VNI-West Consultation Report - Options Assessment

This document has been prepared by Simon Bartlett and Bruce Mountain and is submitted to the AEMO Victorian Planner (AVP) and TransGrid, pursuant to their invitation for submissions on the VNI West Consultation Report Options Assessment (“Consultation Report”).

Figure 7 Breakdown of cumulative gross benefits for Option 5 under the Step Change scenario

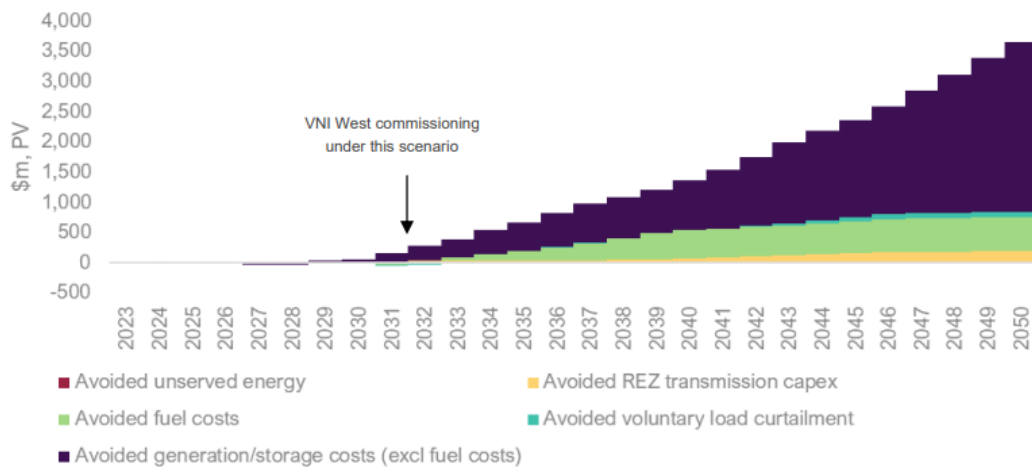
The last three categories combined, reach around \$400m PV by 2040, but somehow grow to \$800m by 2050.

Appendices B, C, F and G provides evidence and reasoning to conclude that the claimed market benefits arise from non-compliances with the National Electricity Law and National Electricity Rules, a completely implausible Base Case and extreme VNI West/WRL congestion causing huge spills of renewable energy attributable to AVP’s assumption that vast amounts of new PV and wind power are installed in the REZ’s along the path of WRL/ VNI West.

5.1.2 Understated WRL Uprate cost

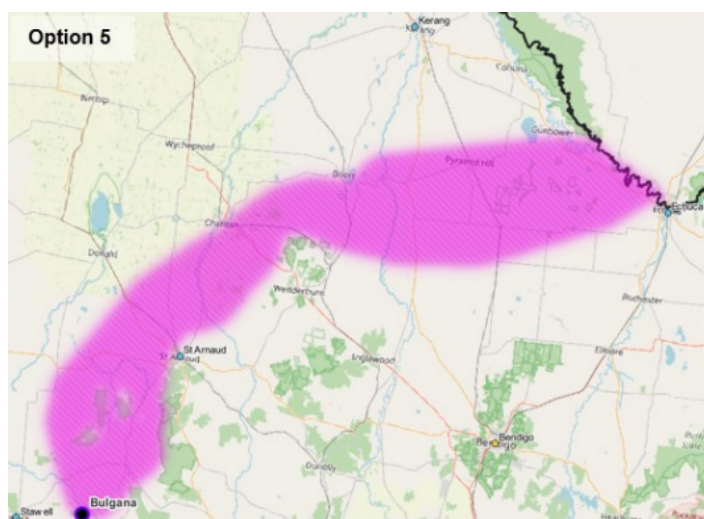
Appendix A.2 of the Consultation Report “Cost estimating methodology for the VIC components” confirms that there is no risk allowance in the VIC 500kV transmission line cost estimates which are based solely on TCD cost estimates. The only allowance for a contingency above the TCD cost estimates is in estimating the WRL uprate costs, however in that case the contingency has been incorrectly applied as shown below. The incremental costs attributed to VNI West for uprating WRL has been calculated as follows:

“To estimate these costs, the per kilometre cost for the current 220 kV line was subtracted from the current market cost for the 500 kV line, while still accounting for known risks by means of an added 30% contingency. The higher voltage line will also require a wider easement[.]”
Reference from Consultation Report

The correct calculation would be to first increase the TCD cost estimate for the 500kV line by 40% (to allow for adjustments and overheads as well as known and unknown risks) subtract AusNet’s costs for the 220kV line no longer required (noting AusNet would have included appropriate contingencies in their contract sum), add in the cost of the additional Waubra 220 kV works and AusNet’s required profits for the uprating and any wasted expenditure on the 220kV line works. The approach used has omitted the 40% contingency required for TCD cost estimates for a 500kV line (i.e., 40% of \$2.91m/km for 104kms (i.e., \$121m), only added a 30% contingency on the difference between AusNet’s price for the 220kV line and the TCD price for 500kV (i.e., \$32m), has omitted the cost of the Waubra works for Option 5 (\$20m?) and it’s unclear how or where AusNet’s wasted expenditure to date and their required profit margin is included. The \$315m allowed in Option 5 appears to be understated by at least \$109m and it is impossible to check how much has been included for the last two items due to the lack of transparency and the use of incremental costs instead of the full cost as required in the RIT-T instrument.

Figure 55 Areas of interest for indicative alignments

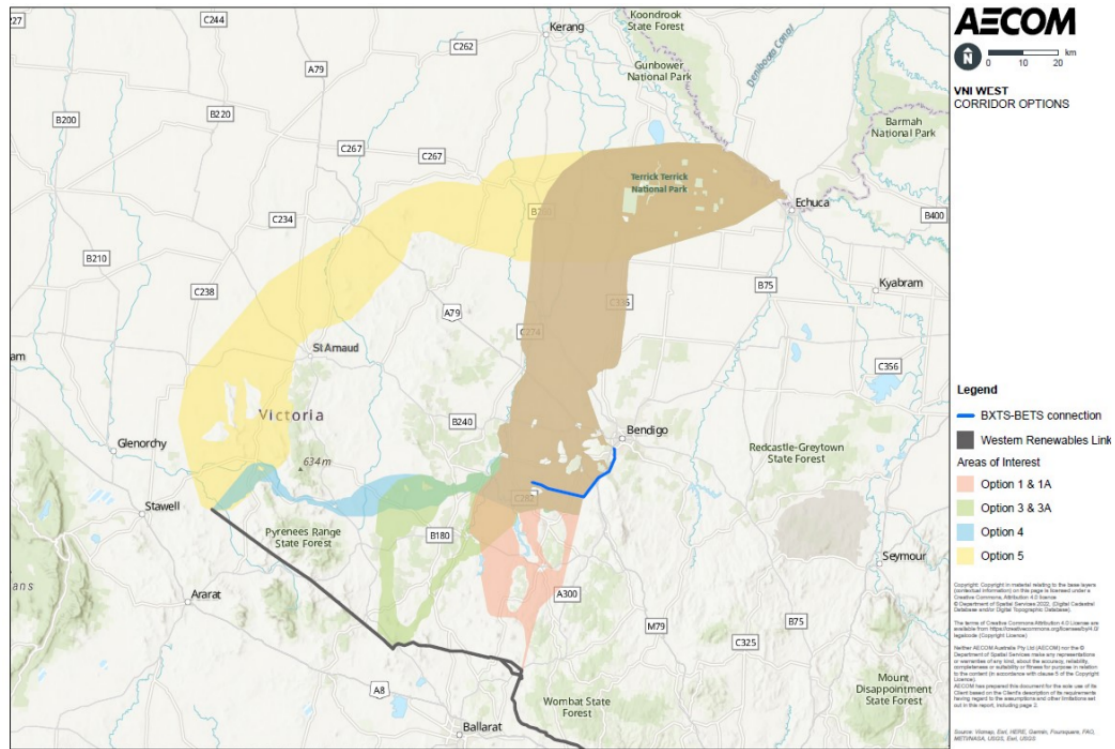
Figure 55 from the Consultation Report, repeated below shows clearly that option 5 is much longer than option 1. Using the scale on this figure, the total length of the 500kv lines between Ballarat and the border crossing point downstream of Echuca is ~335km via WRL and option 5 compared with a ~189km for option 1. The additional 146km would cost \$m596 at \$m4.08/km. This is the increased cost of the 500kV transmission lines from moving the WRL/VNI West connection point from Ballarat to Bulgana. The blue line in figure 55 appears to be a new 35km long 220kV transmission line between

the new Bendigo 500kV/220/kV substation (BXTS) and the existing Bendigo 220kV substation (BETS).

The following table compares the 500kV route lengths in Table 5 of the Consultation Report with the route lengths determined by the three independent assessments. It appears that all options except Option 5 have been over-estimated by 36km to 48km and that Option 5 has been under-estimated by 23 km. Every local knows that Bulgana is further away from the crossing point near Echuca, than North Ballarat or Walcha, and knows that the lengths in Table 5 are clearly wrong. Costing the difference in length for each option at the NSW 500kV line cost of \$4.08m / km results in the cost differences in Table 4 below.

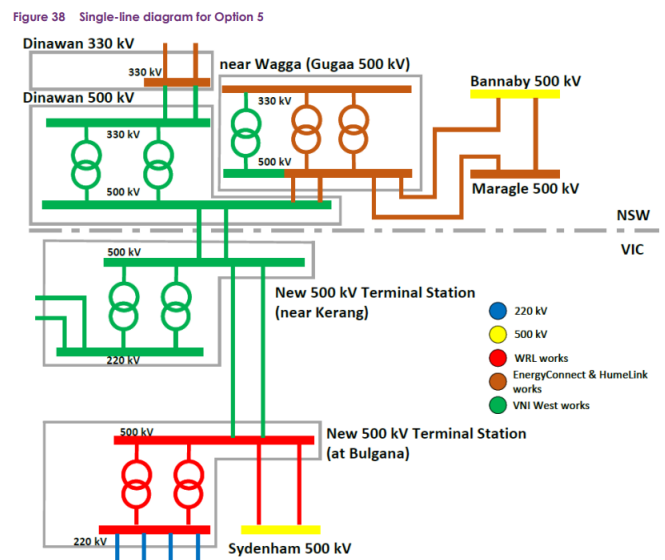
Table 5 of the Consultation Report claims that there are no new substations required in NSW and only one in VIC yet the estimated cost of VIC substations in Option 5 is \$418m compared with \$354m in NSW. In truth, a new 500kV substation is required at Dinawan and two new substations (a 500kV substation and a 220kV substation are required at Kerang, which simplistically, would result in the VIC substation costs being twice the NSW substation cost (i.e., \$708m being twice \$354m compared with the \$418m in Table 5. A closer look below of the required scope of substation works for Option 5 confirms that the VIC works are much greater than the small cost difference implies:

- a. Gugga and Bulgana substations have similar scope of works as both require two additional 500kV switching bays and reactors. Gugga also requires a transformer. Bulgana appears to require four outgoing 220kV feeders shown in blue not required at Gugga or North Ballarat, but it is unclear what their purpose is in the Consultation Report. Bulgana substation may also be required to provide the additional land and various services to the series compensation facilities.

- b. Dinawan requires the establishment of the brown fields 500kV substation with two transformers adjacent to the PEC 330kV substation.
- c. Kerang requires green-field 500kV and 220kV substations requiring extensive excavation and civil engineering works with two transformers, with an access road, auxiliary power supplies, water supply, emergency diesel generators, duplicated telecommunications facilities and security fencing none of which are required at Gugga or Dinawan. It also must provide connections and services to the series compensation at Kerang and the 220kV power flow controllers. These substation servicing costs will be in addition to the costs of the power flow controllers and series compensation and their additional substation costs in Table 5. It is estimated that these additional works would easily add more than \$25m to \$50m to the equivalent brown-field substation costs in NSW.

- d. There are also the additional costs of redesign, scope change, relocation and plant storage costs to vary the existing contract with AusNet Services to enable relocation of the North Ballarat substation to Waubra or Bulgana. Based on the difference between the substation costs between options 1 and 3, these variation costs appear to be around \$63m. This alone accounts for the \$64m difference between the NSW and VIC substation components, without allowing for the large scope difference at Kerang described above.
